### **Merged Document Report**

### **Application No.: PL9049**

| Record Type : | PLAT |

# KASPIAN SUBDIVISION PRELIMINARY PLAT

STORM WATER MANAGEMENT PLAN  
 KASPIAN SUBDIVISION PRELIMINARY PLAT

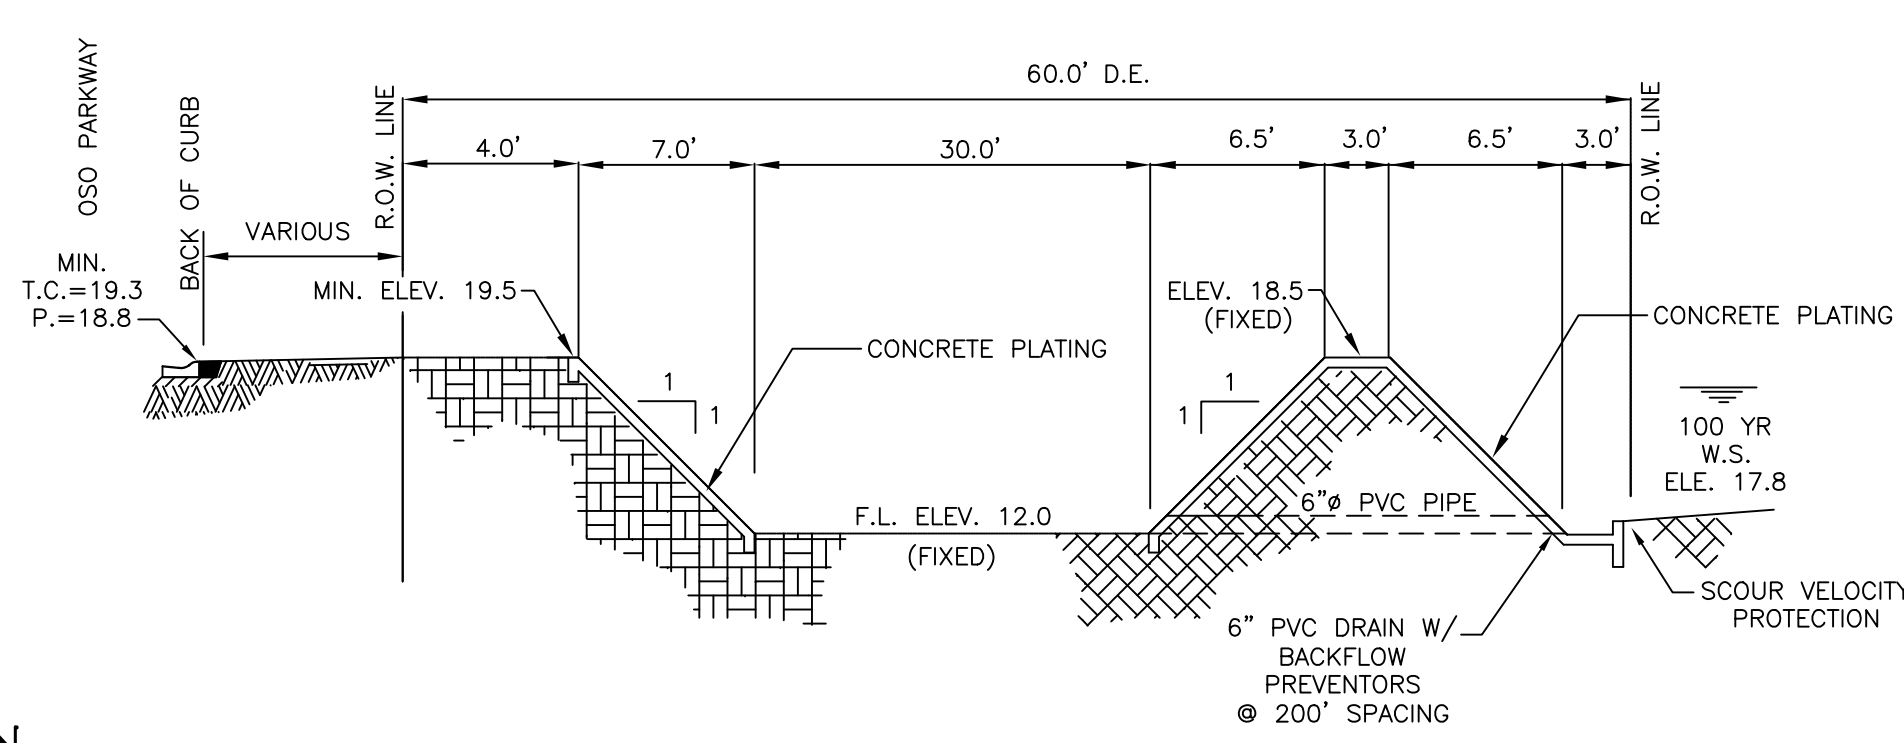
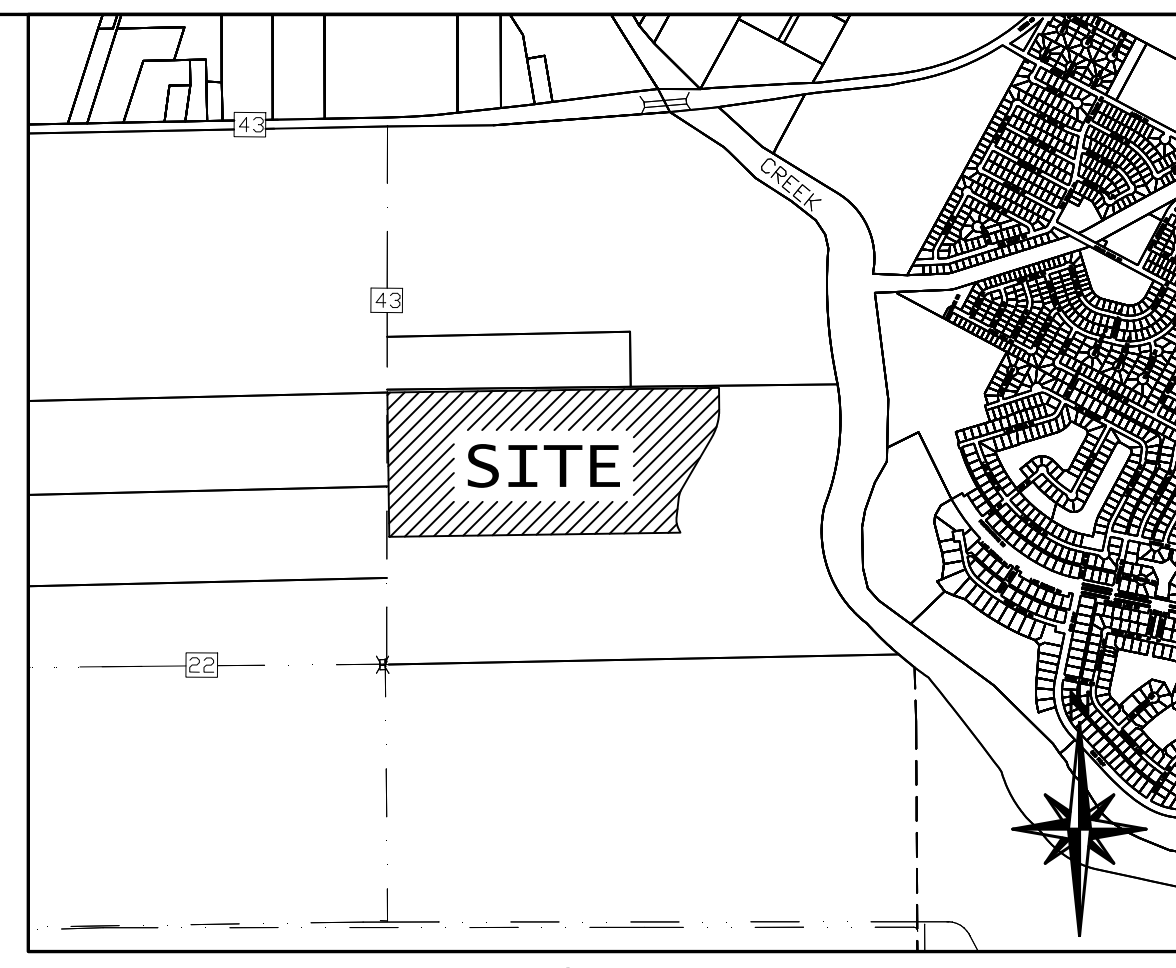
| Comment ID | Page Reference | Annotation Type | Author : Department  | Status | Review Comments   | Applicant Response Comments |
|------------|----------------|-----------------|----------------------|--------|---|-----------------------------|
| 22         | SWQMP          | Note            | Bria Whitmire : DS   | Closed | While sufficient for preliminary plat purposes, is there a concept of how to control the outfall such as to assure post development runoff does not exceed pre development runoff?  |                             |

PRELIMINARY UTILITY PLAN

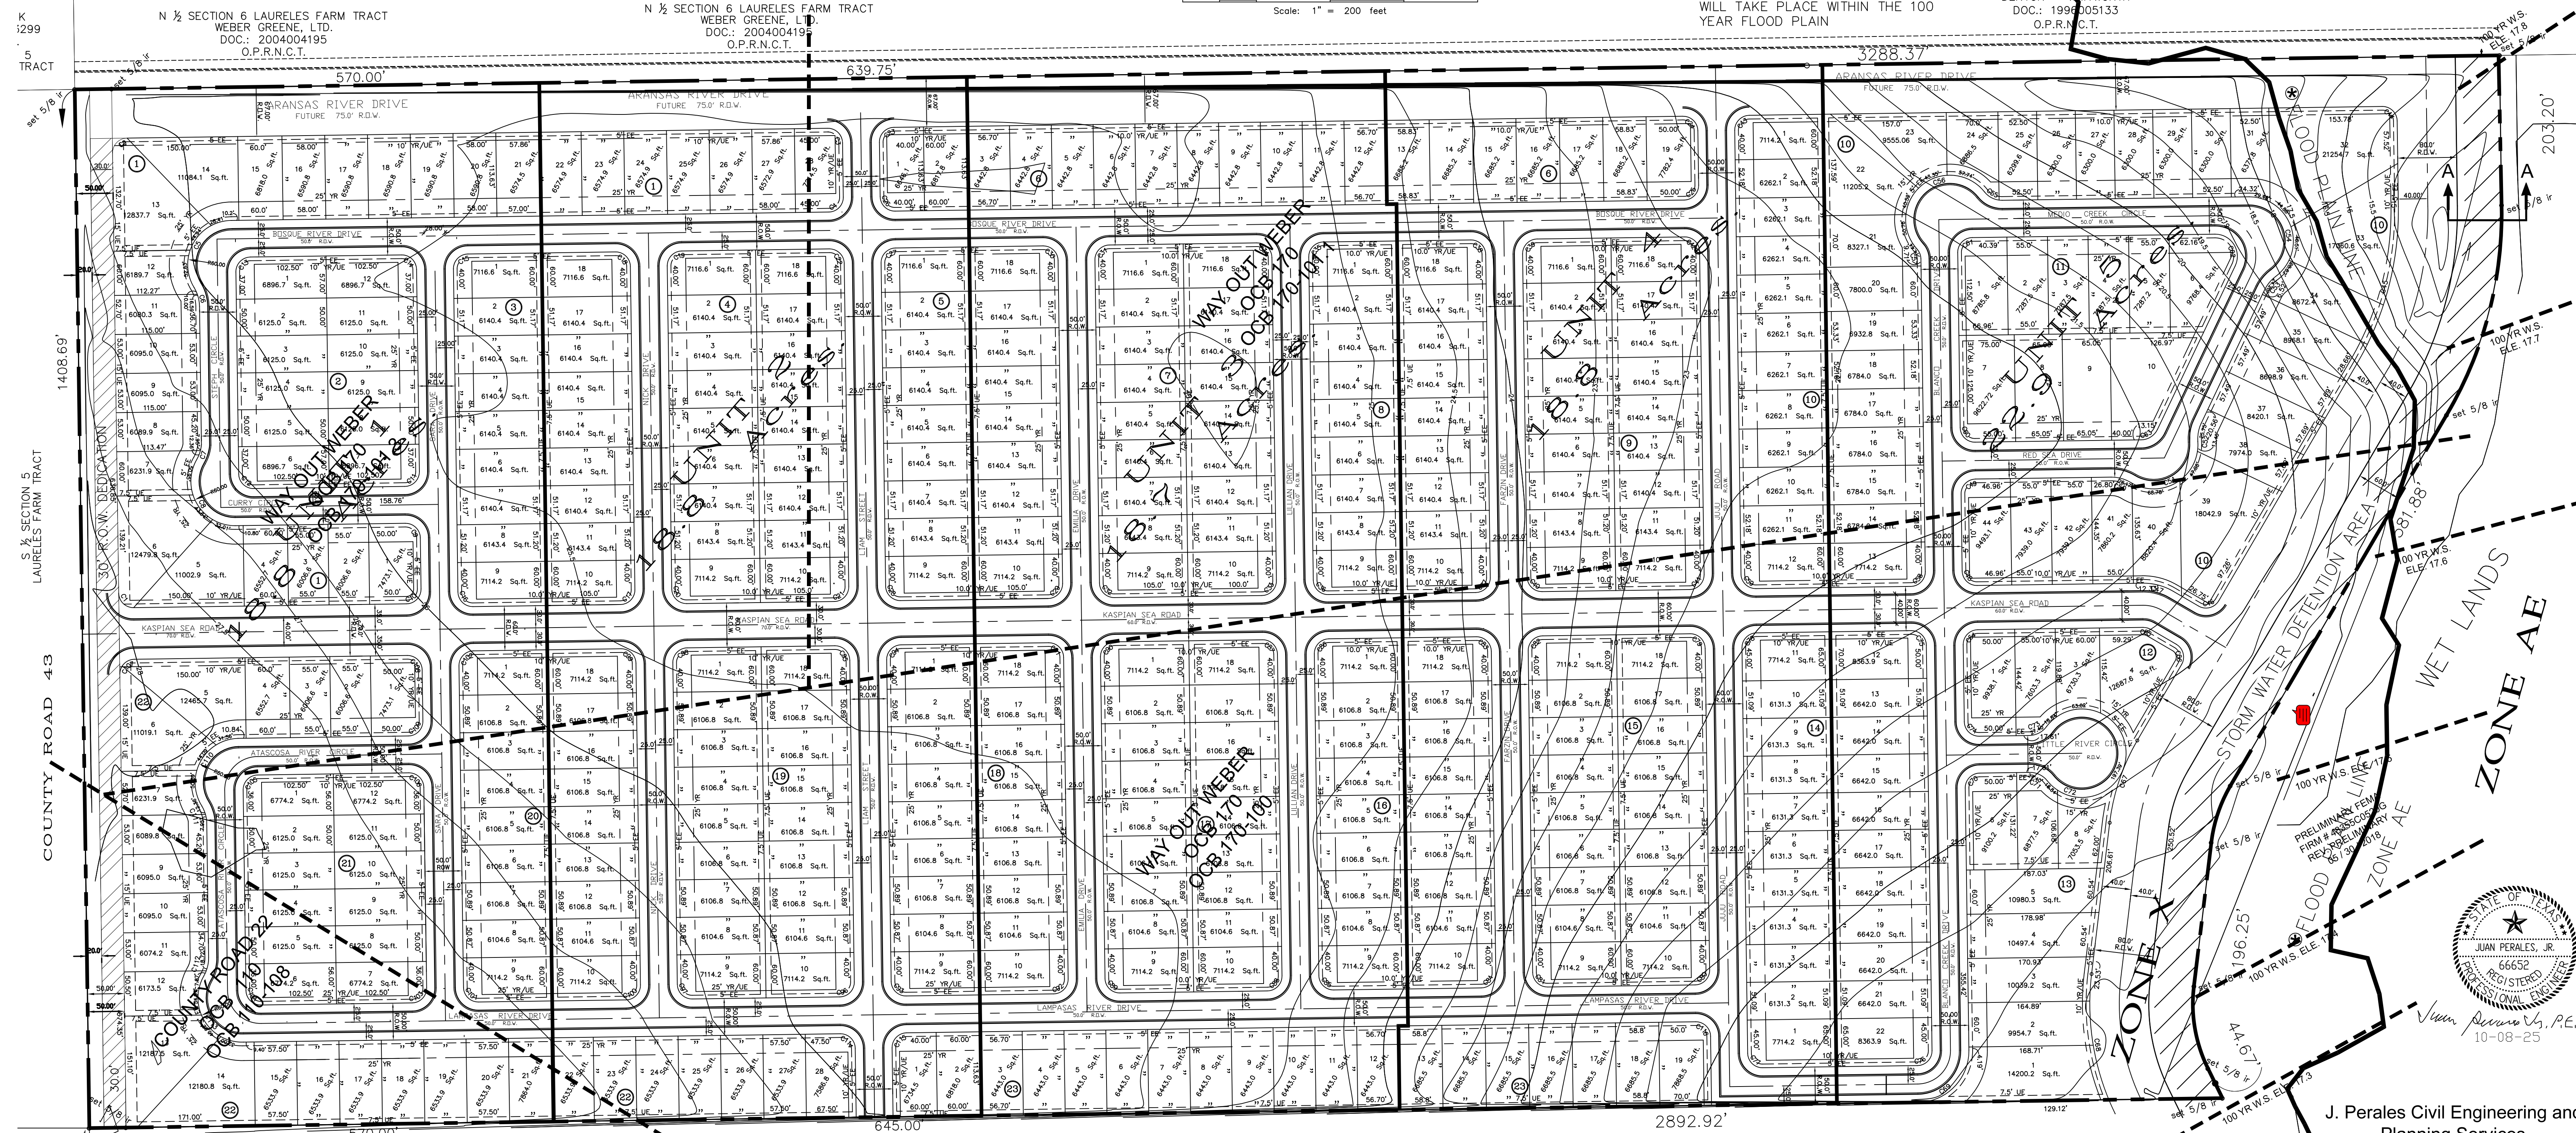
| Comment ID | Page Reference | Annotation Type | Author : Department | Status | Review Comments  | Applicant Response Comments |
|------------|----------------|-----------------|---------------------|--------|--|-----------------------------|
| 20         | U001           | Note            | Bria Whitmire : DS  | Closed | With water/wastewater identified in front of the homes, is rear easement for gas only or for gas and communications? Gas department may have concerns about directionally drilled communications alongside their gas lines so might need to clarify easement purposes.   |                             |
| 21         | U001           | Note            | Mina Trinidad : DS  | Closed | <p>Fire:<br/>(Mark Lewis)</p> <ol style="list-style-type: none"> <li>1. Water Distribution Standards: Fire flow for residential areas require 750 GPM with 20 psi residual</li> <li>2. 507.5.1 Exception 1: Group R-3 (one- or two-family dwellings): Fire hydrants to be located every 600 feet apart.</li> <li>3. 3310.1 Required access. Approved vehicle access for firefighting shall be provided to all construction or demolition sites. Vehicle access shall be provided to within 100 feet of temporary or permanent fire department connections. Vehicle access shall be provided by either temporary or permanent roads, capable of supporting vehicle loading under all weather conditions. Vehicle access shall be maintained until permanent fire apparatus access roads are available.</li> <li>4. D102.1 Access and loading. Facilities, buildings, or portions of buildings hereafter constructed shall be accessible to fire department apparatus by way of an approved fire apparatus access road with an asphalt, concrete or other approved driving surface capable of supporting the imposed load of fire apparatus weighing at least 75,000 pounds.</li> <li>5. 503.1.1 (amendment) Buildings and facilities: During construction, when combustibles are brought on to the site in such quantities as deemed hazardous by the fire official, access roads and a suitable temporary supply of water acceptable the fire department shall be provided and maintained.</li> <li>6. Note: An accessible road and a suitable water supply is required before going vertical with any structure.</li> <li>7. 503.2.1 Dimensions. Fire apparatus access roads shall have an unobstructed width of not less than 20 feet, exclusive of shoulders and an unobstructed vertical clearance of not less than 13 feet 6 inches.</li> <li>8. D103.1 Access road width with a hydrant. Where a fire hydrant is located on a fire apparatus access road, the minimum road width shall be 26 feet, exclusive of shoulders.</li> <li>9. 503.2.5 Dead ends. Dead-end fire apparatus access roads more than 150 feet in length shall</li> </ol> |                             |

| Comment ID | Page Reference | Annotation Type | Author : Department | Status | Review Comments   | Applicant Response Comments |
|------------|----------------|-----------------|---------------------|--------|---|-----------------------------|
|            |                |                 |                     |        | <p>be provided with an approved area for turning around fire apparatus.</p> <p>10. Table D103.4 Requirements for Dead-end fire apparatus access roads. Turnaround provisions shall be provided with a 96-foot diameter cul-de-sac.</p>  |                             |
| 23         | U001           | Note            | Mina Trinidad : DS  | Closed | <p>(Informational) Fire:<br/>(Mark Lewis)</p> <p>9. Where Fire Apparatus Access is constructed to the minimum of 20 feet, no parking is allowed within the fire apparatus lane. Where a fire hydrant is located on the street, the minimum unobstructed clearance shall be 26 feet. In this instance, no parking is allowed on one side of the street. The minimum UDC residential street width is 28 ft. curb to curb. Any parking along the street that reduces the width to less than 20 ft. is prohibited and the Fire Code Official and will require painting "NO PARKING-FIRE LANE" along one side of the street.</p> <p>10. Note: Calculated Turning Radii for Fire Apparatus:<br/> Inside Turn: 20 ft. 3 in.<br/> Curb to curb: 36 ft. 8 in.<br/> Wall to wall: 44 ft. 8 in.</p> <p>11. It is noted that the intersection of Medio Creek Circle and Red Sea Dr. creates a sharp turn. If the turning radius does not meet our requirements, then this turn will need to be widened for a fire apparatus to negotiate the turn without have to back-up.</p> <p>12. 503.4 Obstruction of fire apparatus access roads. Fire apparatus access roads shall not be obstructed in any manner, including the parking of vehicles. The minimum widths and clearances established in sections D103 shall always be maintained.</p> <p>13. 503.3 Marking: Where required by the fire code official, approved signs, or other approved notices the include the words NO PARKING-FIRE LANE shall be provided for fire apparatus access roads to identify such roads to prohibit the obstruction thereof. The designation of a fire lane can be marked with conspicuous signs which have the words:" Fire Lane-No Parking" at 50-foot intervals. In lieu of signs, fire lanes may be marked along curbing with the wording, "Fire Lane-No Parking" at 15-foot intervals.</p> <p>14. D107.1 One- or two-family dwelling residential developments. Developments of one- or two-family dwellings where the number of dwelling units exceeds 50 shall be provided with two separate and approved fire apparatus access roads.</p> |                             |

| Comment ID | Page Reference | Annotation Type | Author : Department | Status   | Review Comments  | Applicant Response Comments |
|------------|----------------|-----------------|---------------------|----------|--|-----------------------------|
|            |                |                 |                     |          | <p>Exceptions:</p> <ul style="list-style-type: none"> <li>- Where there are more than 50 dwelling units on a single public or private fire apparatus access road and all dwelling units are equipped throughout with an approved automatic sprinkler system, access from two directions shall not be required.</li> <li>- The number of dwelling units on a single fire apparatus access road shall not be increased unless fire apparatus access roads will connect with future development, as determined by the fire code official.</li> </ul>  |                             |
| 24         | U001           | Note            | Mina Trinidad : DS  | Closed   | <p>(Informational) Fire:<br/>(Mark Lewis)<br/>15. D107.2 Remoteness. Where two fire apparatus access roads are required, they shall be placed a distance apart equal to not less than one-half of the length of the maximum overall diagonal dimension of the property or area to be served, measured in a straight line between accesses. Unless otherwise approved by the Fire Marshal.<br/>16. The plat indicated that there will be two points of entry into this subdivision. One being Kaspian Sea Drive and the other Aransas River Dr. It appears that Aransas River Drive is preliminary. As with other reviews, allowance will be made to built up to 50 homes. Once the 51st. home foundation is laid, the Aransas River Drive connection to CR. 43 (Weber Rd.) is to be completed.</p> |                             |
| 25         | U001           | Note            | Bria Whitmire : DS  | Closed   | <p>7.5' UE at southern property line does not connect where road goes to the edge of the property. What infrastructure is in this easement that it does not need to continue to connect at Blanco Creek?</p>   |                             |
| 28         | U001           | Note            | Mina Trinidad : DS  | Closed   | <p>Fire:<br/>(Mark Lewis)<br/>It is noted that the intersection of Medio Creek Circle and Red Sea Dr. creates a sharp turn. If the turning radius does not meet our requirements, then this turn will need to be widened for a fire apparatus to negotiate the turn without having to back-up<br/>The plat indicated that there will be two points of entry into this subdivision. One being Kaspian Sea Drive and the other Aransas River Dr. It appears that Aransas River Drive is preliminary. As with other reviews, allowance will be made to build up to 50 homes. Once the 51st. home foundation is laid, the Aransas River Drive connection to CR. 43 (Weber Rd.) is to be completed.</p>   |                             |
| 31         | U001           | Note            | Mina Trinidad : DS  | Migrated | <p>03/06/26 Update: It appears that the 5'UEs on Lots 22 and 23 Blk 23 have been removed on this latest version for submittal. The Gas Department</p>  |                             |

| Comment ID | Page Reference | Annotation Type | Author : Department | Status   | Review Comments  | Applicant Response Comments |
|------------|----------------|-----------------|---------------------|----------|--|-----------------------------|
|            |                |                 |                     |          | <p>would like to request that these easements be put back on those lots. We need at least one of them for looping/back feed purposes, not sure why they were removed.</p> <p>02/02/26 Update: Gas Department would like to request a 5' UE on Lot 20 BLK 10 and a 5' UE on Lot 12 BLK 14 as shown on attached map. (Under attachments in Customer Portal)</p> <p>Gas Department:<br/>(Keith Rodriguez)<br/>Please see attached for gas easements requested in red for Kaspian Subdivision.</p> |                             |
| 38         | U001           | Note            | Mina Trinidad : DS  | Migrated | <p>(Informational) CCW:<br/>(Edgar Diaz Ruiz)<br/>Water construction is required for platting (UDC 1.2.1.D &amp; 8.2.6; Water Distribution Standards). All water improvements to be address during Public Improvements Phase.<br/>Wastewater construction is required for platting (UDC 1.2.1.D &amp; 8.2.7; Wastewater Collection System Standards). All wastewater improvements to be address during Public Improvements Phase.</p>  |                             |
